**Residential/commercial subdivision, Pt Lot 402  
Rae Road, Cockburn Sound Location 16,  
Rockingham.**

**Report and recommendations  
of the Environmental Protection Authority**

**Environmental Protection Authority  
Perth, Western Australia  
Bulletin 892  
May 1998**

Figure 3. Recommended P&R reserve modification and location of Vegetation Community 19.

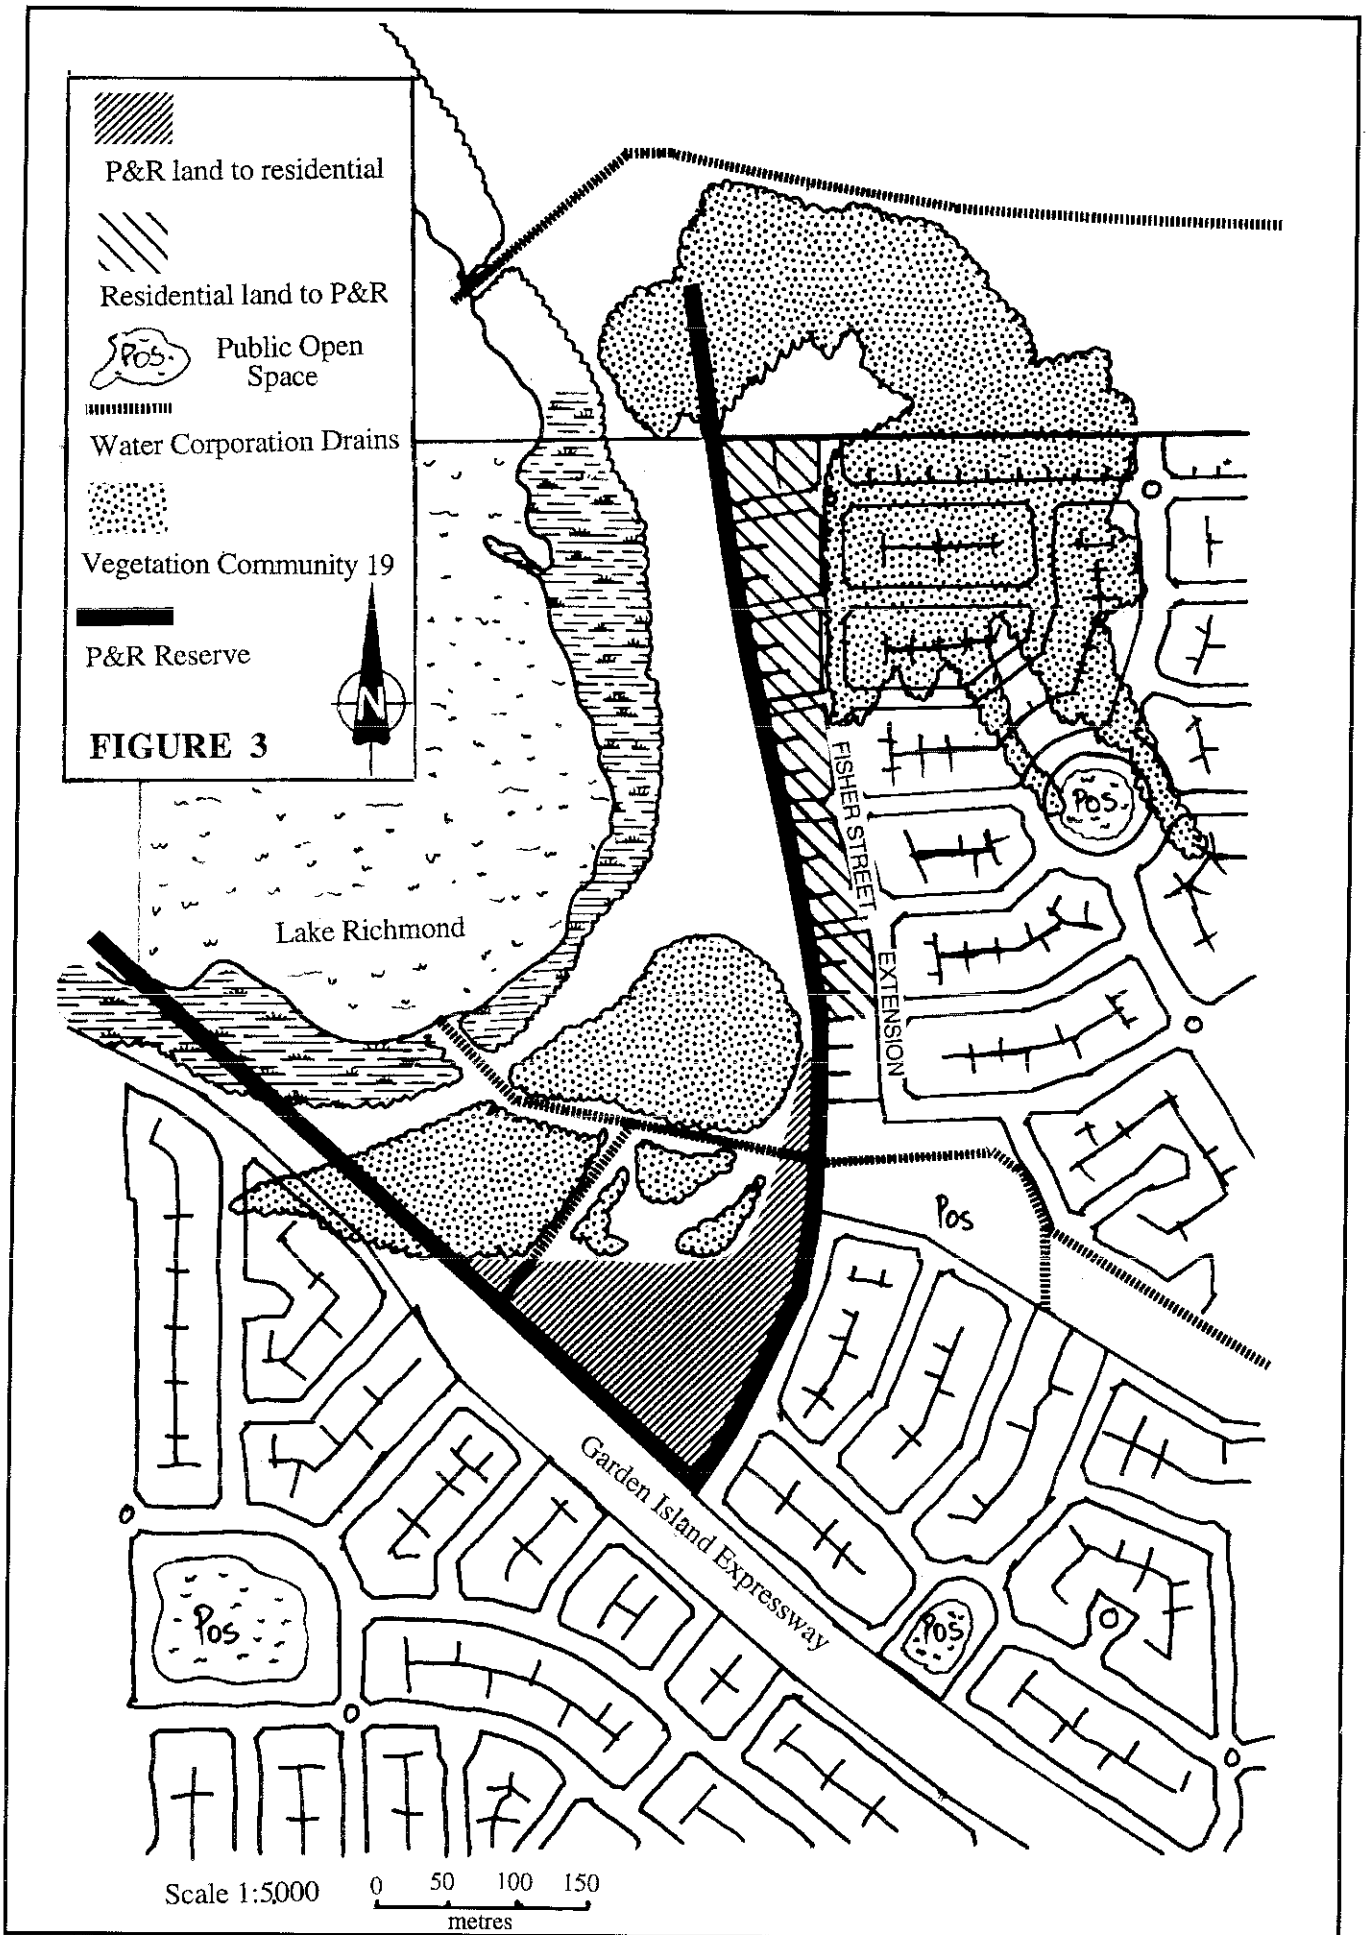
The P&R Reserve contains Lake Richmond and its riparian and dryland vegetation. The setback from the development to Lake Richmond's high water mark is 70 to 370 metres (average 160 metres) (Figure 3). This may not provide an adequate buffer to the Lake and the thrombolites within the Lake.

Submissions by the WRC and CALM questioned the adequacy of the existing P&R Reserve as a buffer to protect the water quality and thrombolites in Lake Richmond.

CALM has recommended a buffer of 200 metres and advised that Lake Richmond supports the only known living occurrence of this type of thrombolite community (cyanobacteria genus *Dicothrix*). CALM has stated that *"If wrong decisions are taken and this occurrence dies, a fascinating and scientifically significant piece of Western Australia's biological diversity will be lost forever. Every reasonable care should be taken to ensure this does not happen."* CALM believes that on first principles a larger buffer is more desirable than a smaller one and as such provides greater protection (thrombolites and Vegetation Community 19), space for management and as a general safeguard.

WRC has advised that the buffer can be less than 200m, provided management of drainage water is consistent with best environmental practice (water sensitive design), a more uniform buffer is achieved by modifying the P&R Reserve to the east of Lake Richmond so that it reflects an ecological rather than cadastral boundary and there is revegetation of degraded areas within the P&R Reserve.

Based on all the information, the specific circumstances with respect to Lake Richmond and the proposal, the EPA concludes that the buffer should be increased on the eastern margin of Lake Richmond to achieve a minimum 100 metre setback between the development and the riparian (wetland dependent) vegetation. There is the opportunity to achieve this without significantly reducing the area available for development by exchanging current P&R Reserved land, which is cleared, next to the Garden Island Expressway, with land to the west of Fisher Street (Figure 3).

it is the EPA's opinion that the objective can be met subject to the modification of the P&R Reserve in accordance with the notional land exchange occurring, as depicted in Figure 3.

Figure 3. Recommended P&R reserve modification and location of Vegetation Community 19.

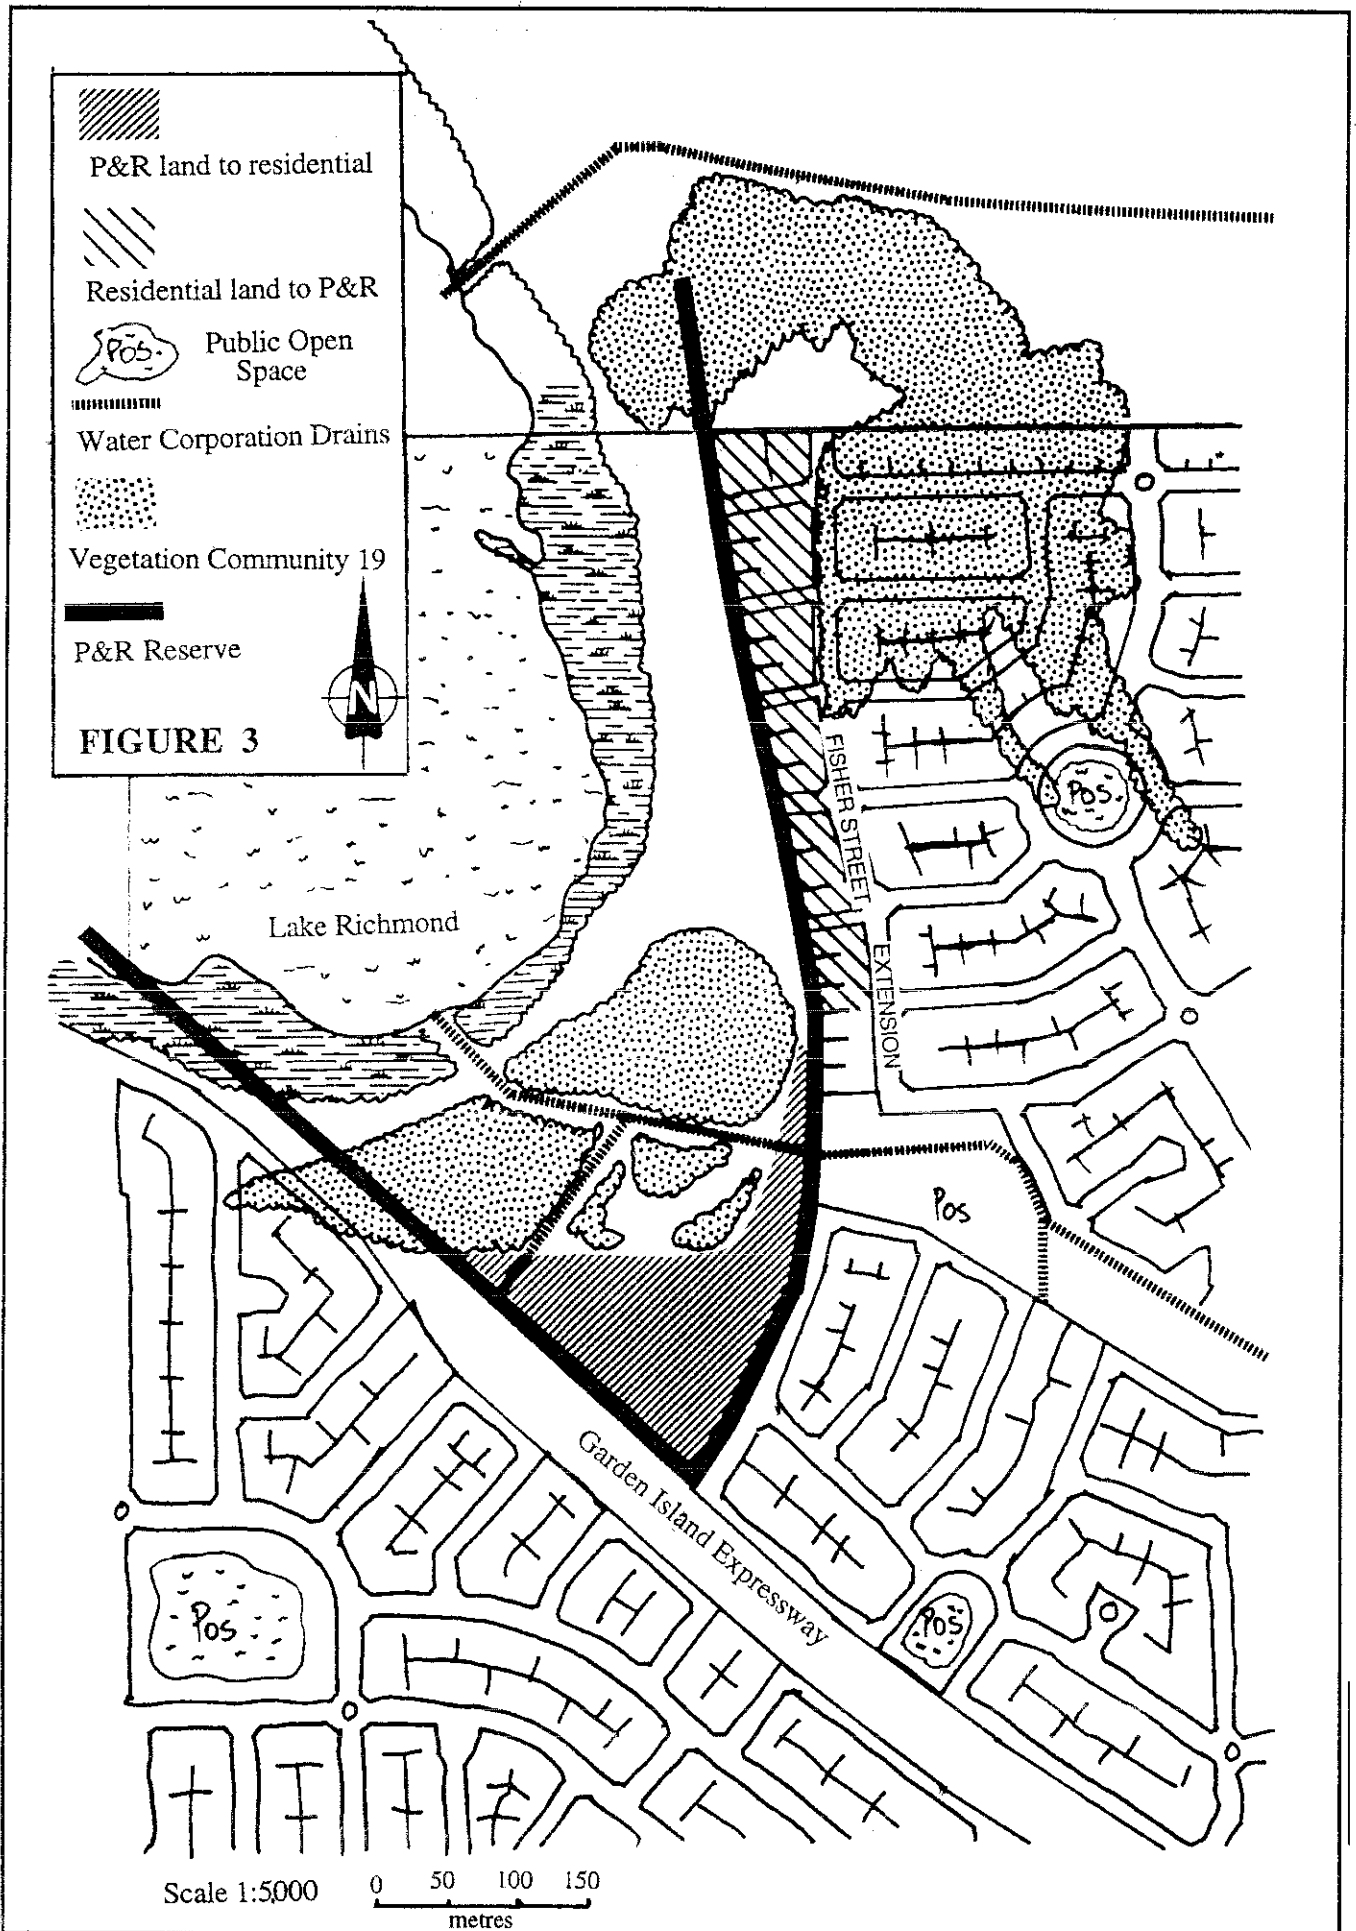
- 1 the boundary of the Parks and Recreation Reserve on the eastern side of Lake Richmond shall be no less than 100 metres from the outermost extent of the wetland dependent vegetation; and
- 2 the Parks and Recreation Reserve may exclude the degraded land in the southern portion of the Parks and Recreation Reserve shown in Figure 1 in Schedule 1 of this statement;

as shown in principle in Figure 3 in Schedule 1 of this statement.
